CALIFORNIA COASTAL COMMISSION

STAFF REPORT: REGULAR CALENDAR

APPLICATION NO.: 4-00-044

APPLICANT: Blank Par-E, LLC

EXHIBIT 6
CDP 4-00-044 (Blank Par-E, LLC)
Resource Map

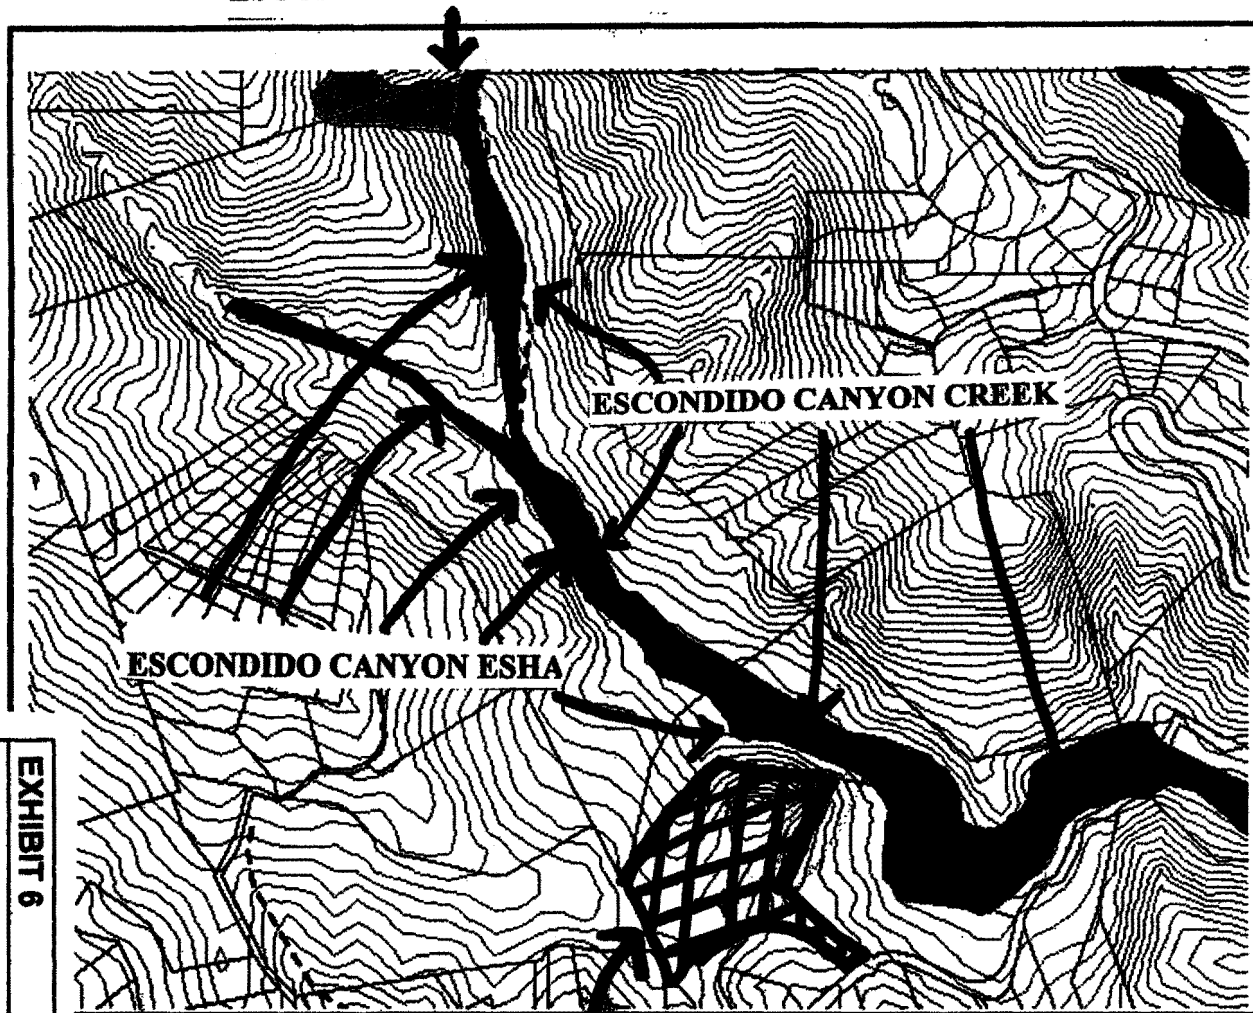
In addition, the Coastal Act defines environmentally sensitive habitat areas (ESHAs) as any area in which plant or animal life or their habitats are either rare or especially valuable because of their special nature or role in an ecosystem and which could be easily disturbed or degraded by human activities and development. Section 30240 of the Coastal Act permits development in areas that have been designated as ESHA only when the location of the proposed development is dependent upon those habitat resources and when such development is protected against significant reduction in value. As previously mentioned, the Malibu/Santa Monica Mountains LUP has also designated this portion of Escondido Canyon and Escondido Canyon Creek as an ESHA, specifically an inland ESHA due to the extensive undisturbed riparian vegetation (Exhibit 6).

Vegetation and Sensitive Resources Map

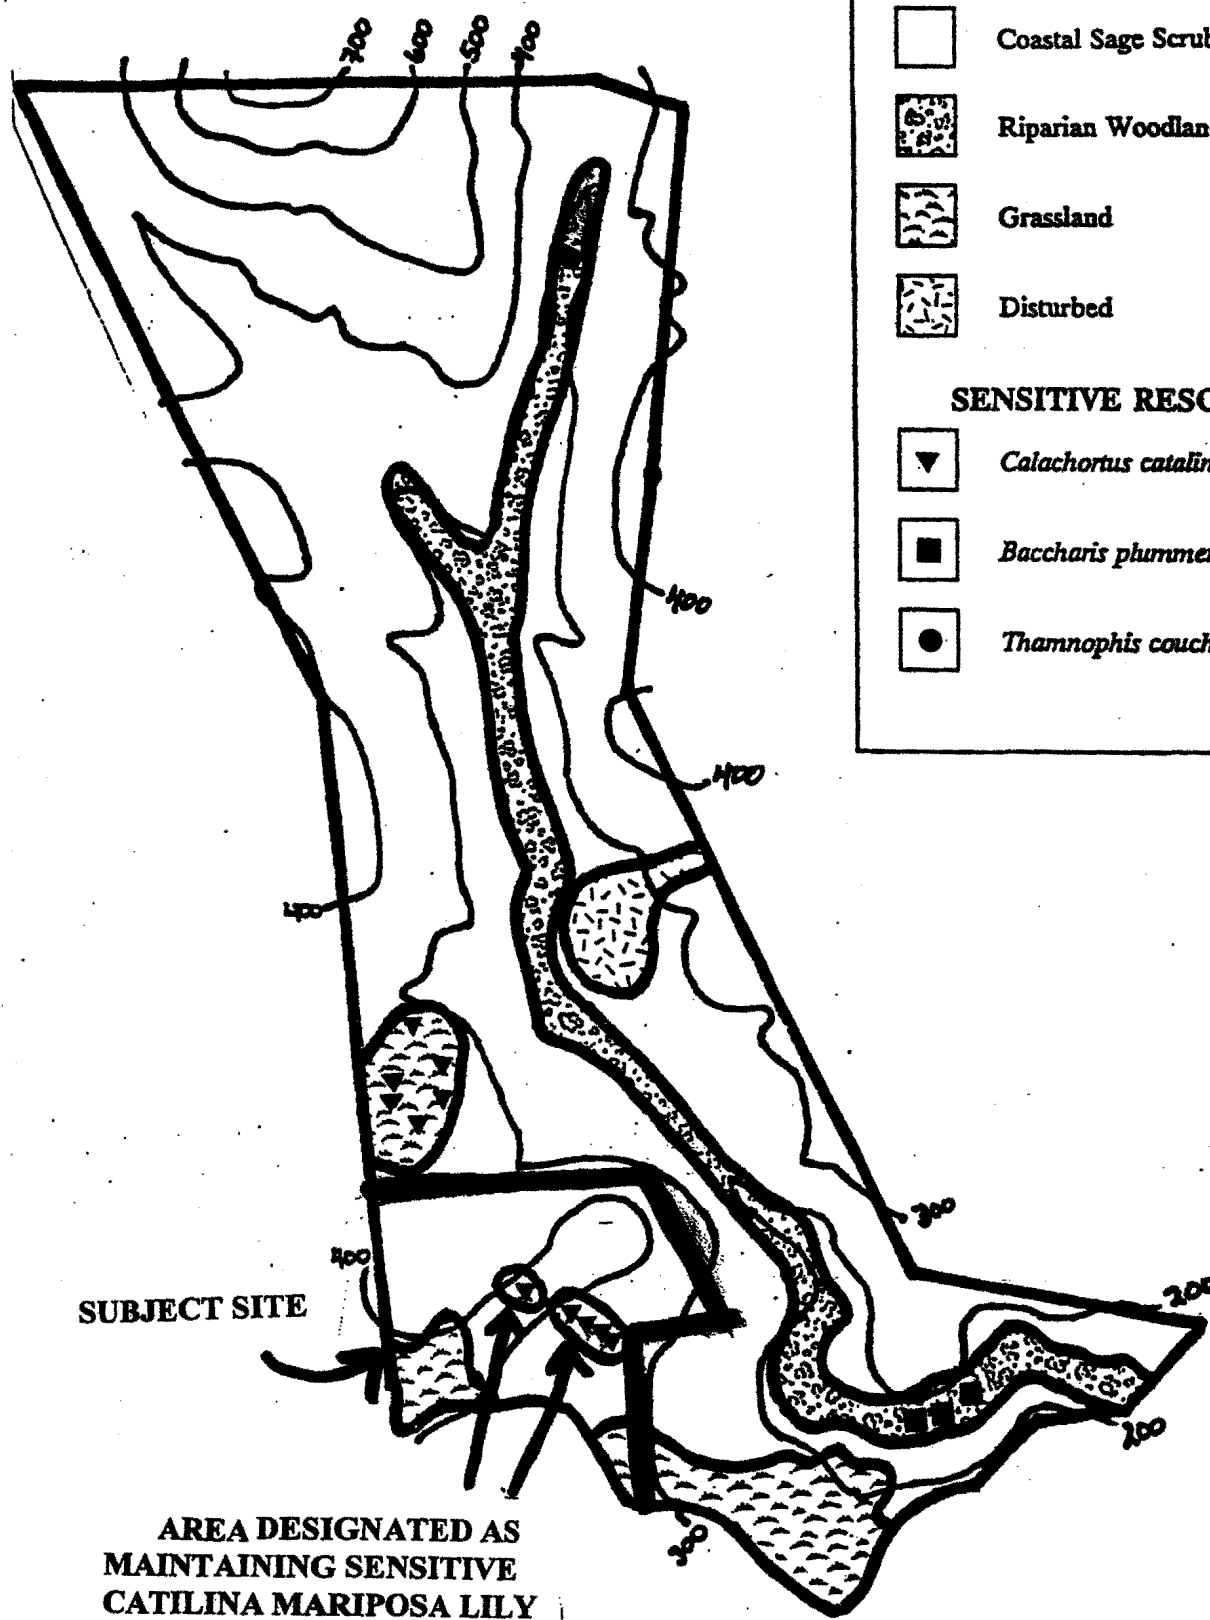
As a result, under **Special Condition Two (2)**, the landscape plan shall specifically include the use of the Catalina Mariposa Lily ("Calochortus catalinae"), as this sensitive species was noted in the biological survey of the site where the development is proposed and were noted on the site by Staff during a site visit (Exhibit 7).
